APPLICATION NO.	FILING DATE	FIRST NAMED INVENTOR	ATTORNEY DOCKET NO.	CONFIRMATION NO.
10/817,235	04/02/2004	Dennis M. Brown	SP03-053	3064
22928	7590	02/14/2006	EXAMINER	
CORNING INCORPORATED			WONG, TINA MEI SENG	
SP-TI-3-1			ART UNIT	PAPER NUMBER
CORNING, NY 14831			2874

Office Action Summary	Application No. 10/817,235	Applicant(s) BROWN ET AL.	
	Examiner Tina M. Wong	Art Unit 2874

DETAILED ACTION

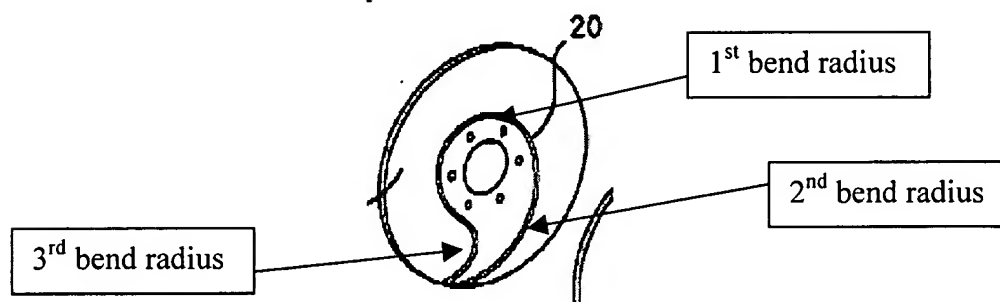
Referring to Applicant's prior art Figure 2, groove 20 has 3 different bend radii. Since Applicant has claimed each groove to have a different bend radius and groove 20 has 3 different bend radii, Applicant's prior art Figure 2 shows a plurality of connected grooves.

Applicant also argues the prior art relied upon by the Examiner fails to show a plurality of grooves on one flange. However, the Examiner disagrees. Applicant claims each groove on the single flange to have a different bend radius (R_i). Referring to Applicant’s prior art Figure 2 below, it can be seen that three different radii are on the single flange. Each radius is connected together creating three grooves, each with a different bend radius, all connected together.
